## the parsonage

4132 brooklyn avenue ne  
seattle, wa 98105

DRB Recommendation Meeting  
DPD project #3018666

31 august 2015

## 2 | ALLEY DESIGN | shared solid waste and recycling area

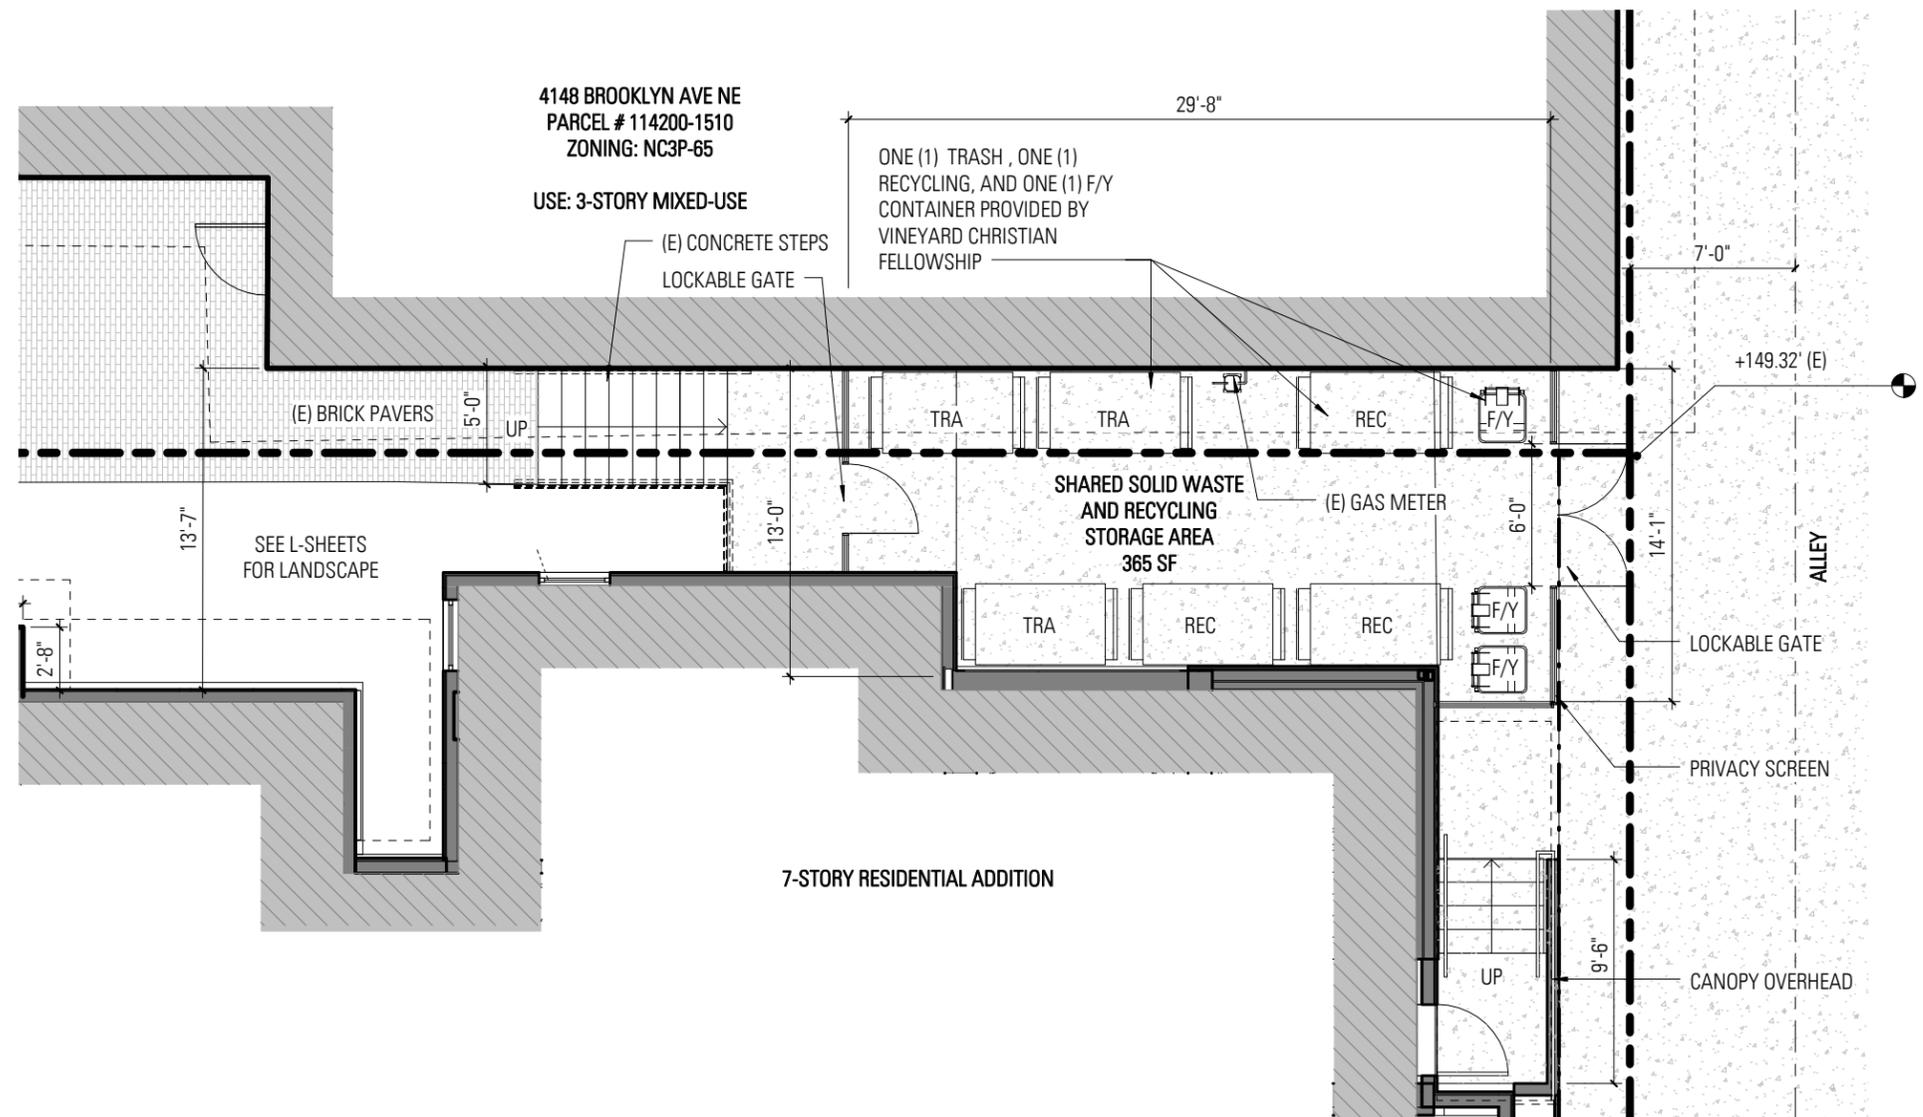
2d) Alley Design and Rear Setback Departure, Shared Solid Waste Storage. The Board supported the applicant's intent to work with the adjacent church to co-locate solid waste and recycling storage space location.

Applicant has worked closely with church to create a shared solid waste and recycling storage area which has been approved by Liz Kain, SPU.

### 3 | RELATIONSHIP TO THE CHURCH | design concept and architectural composition

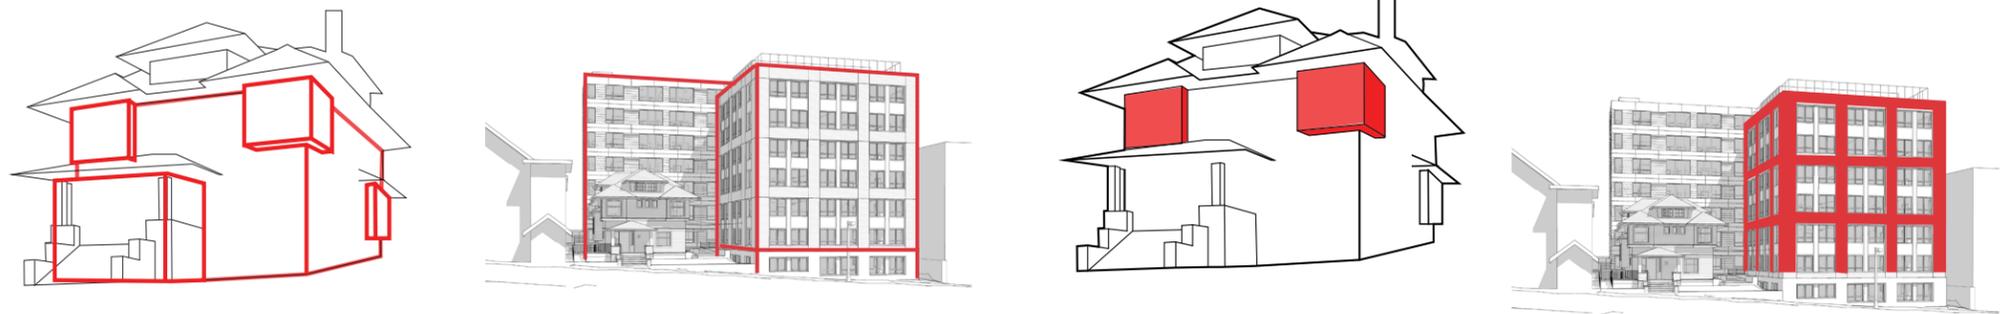
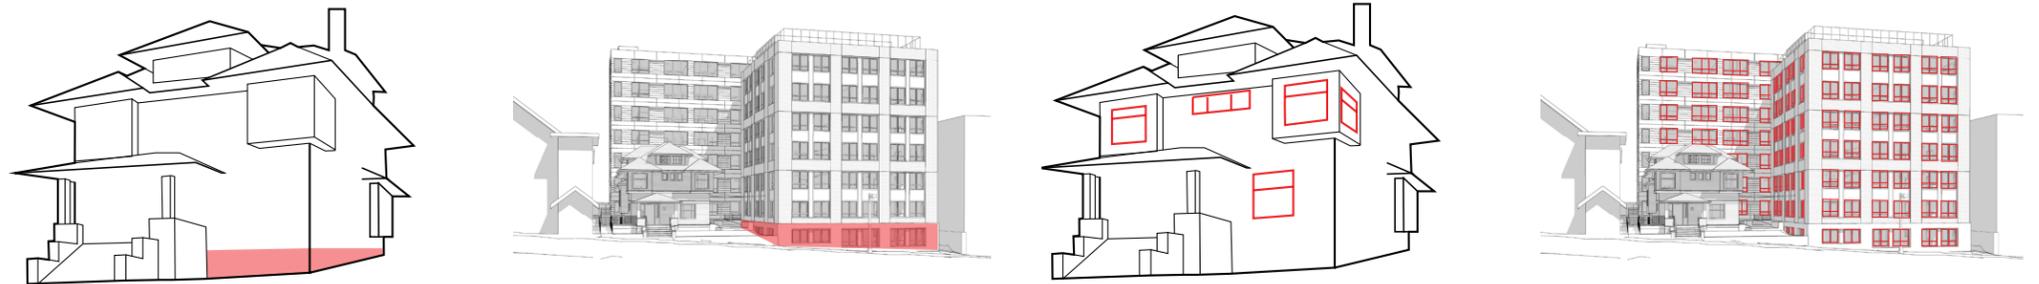
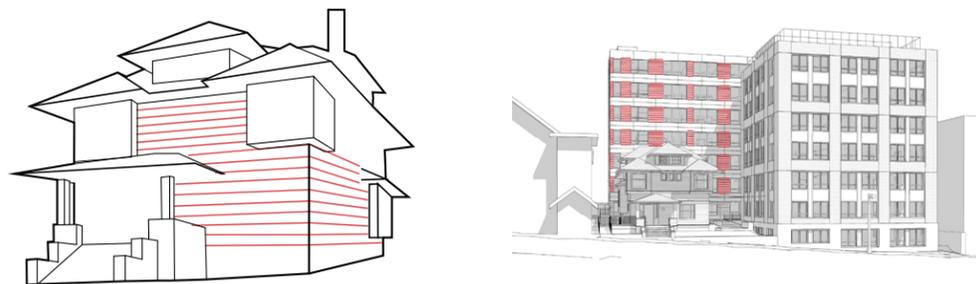
9. Design Review, Design Concept & Architectural Composition (DC2-A, DC2-B, DC2-E, DC3-A). Please demonstrate the intended overall concept between the massing and architectural composition of the existing structure and the proposed development.

The proposed design picks up on architectural language from the Parsonage and also the Church (see next page) to inform the design of the New Addition.

perspective view at street-level

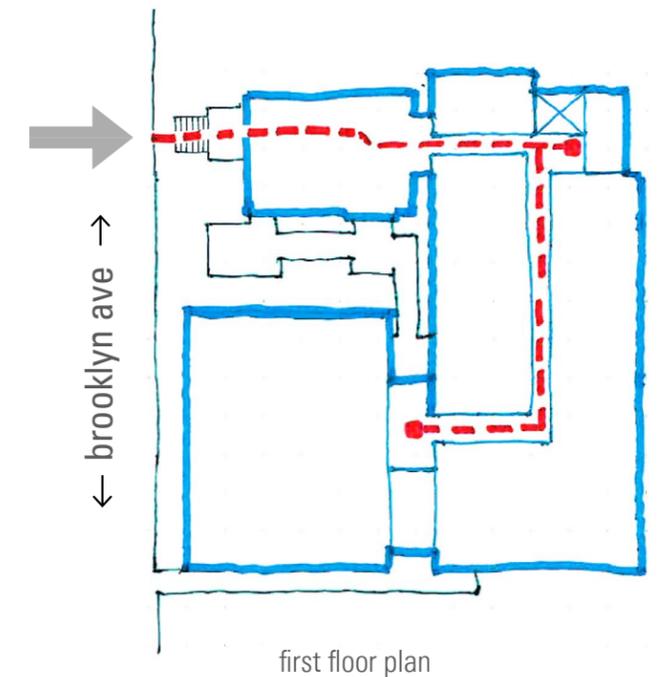
7. Design Review, Entry Location, Wayfinding and Legibility. (PL2-D, PL3-A, DC1-A). The main entry to the new portion of the development is not easily discernible. Residents and visitors must enter through the historic structure, which may appear as separate from the newer portion of the development due to the courtyard. The entries should be prominent and easily identifiable.

Consider relocating the main entry to the new residential structure at the terminus of the courtyard from Brooklyn; a direct or visual connection from the street to the entry could be further emphasized with a vertical feature or change in materials or modulation.

There is intentionally only one public access point as part of the ingress/egress controls and the residential life program. It is intended that the "Parsonage House" be the main entry, with wide welcoming stairs leading up to the porch, with signage and address (and the fact that there is no other visible and accessible entry from Brooklyn) will make it obvious that it is the main entry.

Location of signage and address will be further refined with the Landmarks Board.

ground level units at floor 1

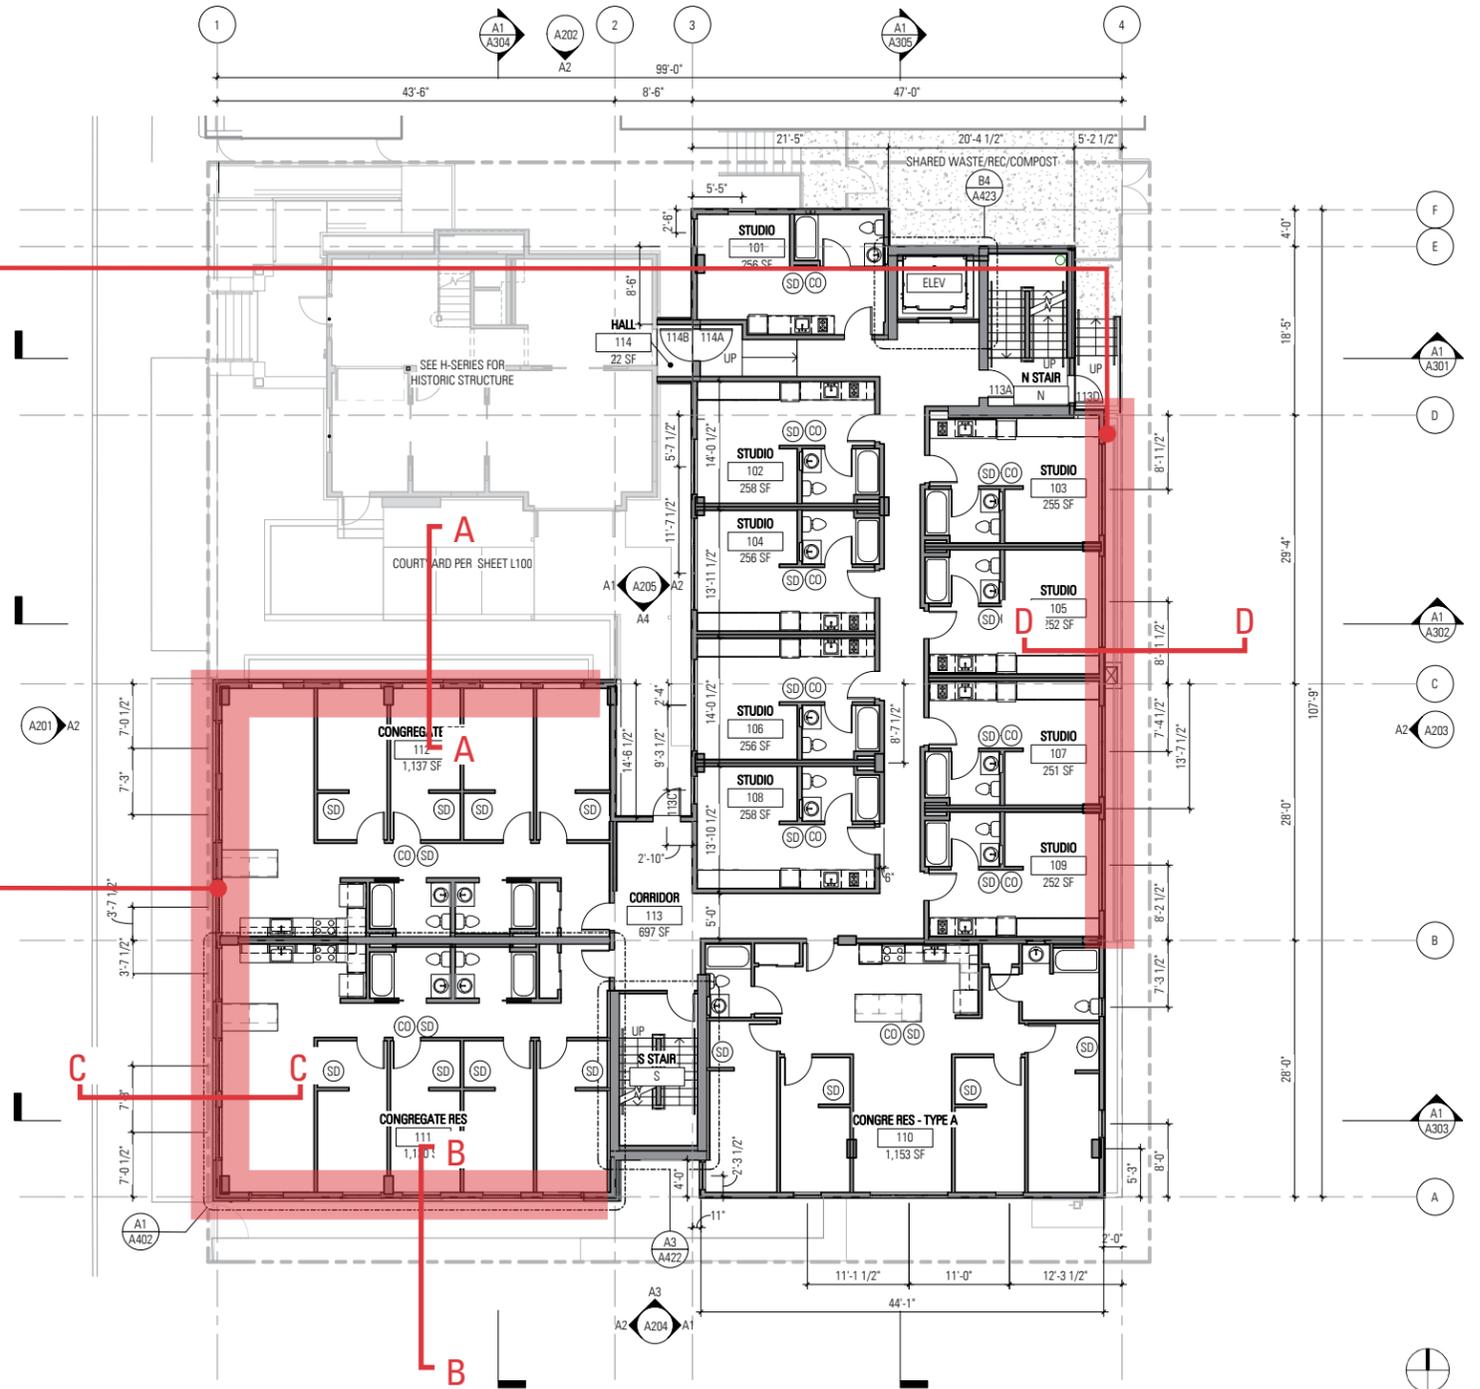
8. Design Review, Ground-Level Units (PL3-B). Please clarify the purpose of dead-end walkway to the north of the units. Will this present security issues? Is there an opportunity to tie this into ramping for courtyard access? The space is not contributing to the overall design of the courtyard, and further reduces the opportunity for usable space at the upper levels.

In addition, provide more detail regarding the bicycle access to the south of the ground-level units. Will the entrance be easily identifiable? If there is expected to be heavy use of the bicycle storage, consider the privacy implications on the units, and if a buffer or revised location is appropriate.

The walkway at the south end of the courtyard has been replaced by a light well with a short retaining wall to hold back the rest of the courtyard and provides a good grade transition for the adjacent units. The gate has been removed to clarify that it is not a walkway.

The bicycle storage has been moved to the south side of the building, where the lower grade allows direct, "at-grade" access directly into a large, well lit, well secured, large bicycle storage room. While this entry is easily identifiable by all residents, it is not intended for use by visitors.
